Madison West Neighborhood Association

**From: David Handowski, Chair and Organizer of the Madison West Neighborhood Association
Neighborhood Plan Review Committee**

**Re: Additional information and analysis regarding Jeffy Trail not included or incorrect in the
proposed High Point Raymond Neighborhood Development Plan**

Map #5 of the proposed NDP – Existing Zoning fronting the proposed Jeffy Trail street extension

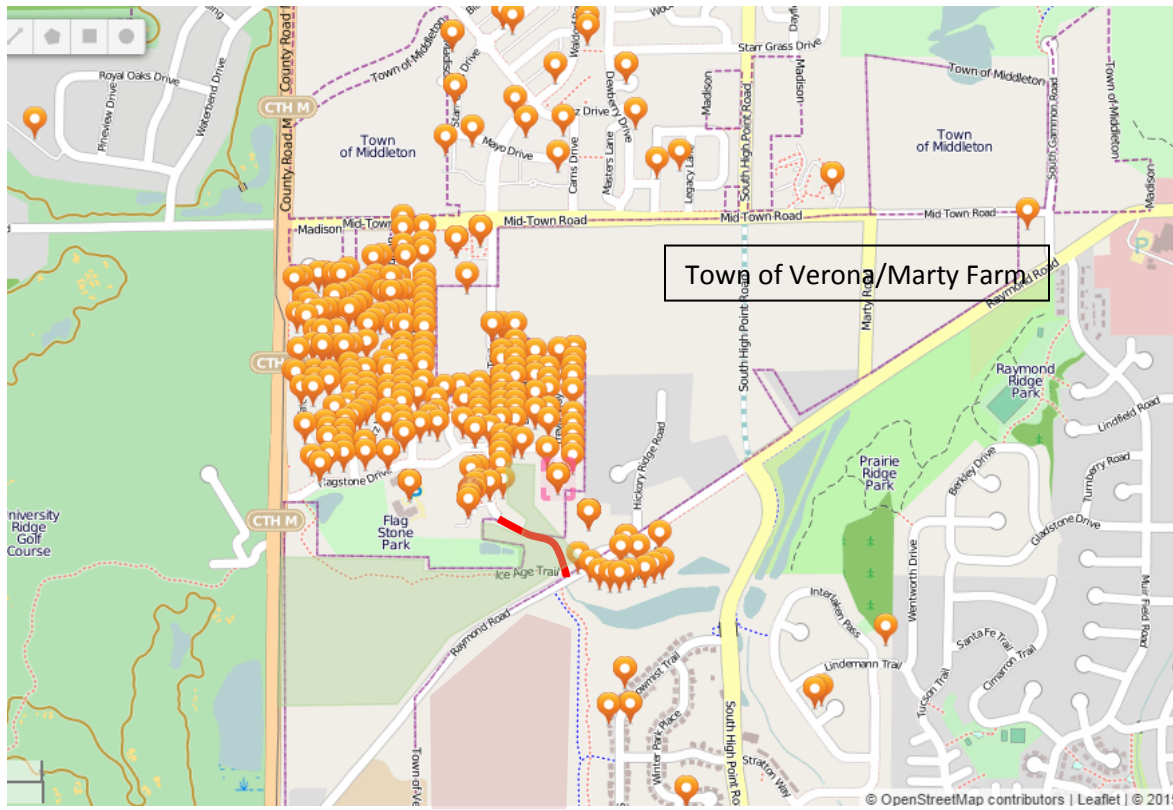
Misleading and incorrect information: The zoning map shows the length of the proposed Jeffy Trail street extension as traversing residential zoning. This is both incorrect and highly misleading. As agreed upon following the City's purchase of the Smithies property from the Audubon Society, the land on either side of the potential future Jeffy Trail extension was to be zoned "Conservancy." In May 2013, **the Common Council enacted Resolution #29422 which approved the zoning of the Smithies/Audubon Society land that the street would front traverse as Conservancy.** The West Madison Neighborhood Association has repeatedly informed the Planning Department that the land was zoned conservancy – a fact that they have sought to avoid. The street extension would serve only a single 0.67 acre parcel zoned residential just 40 feet from the current end of the Jeffy Trail street.
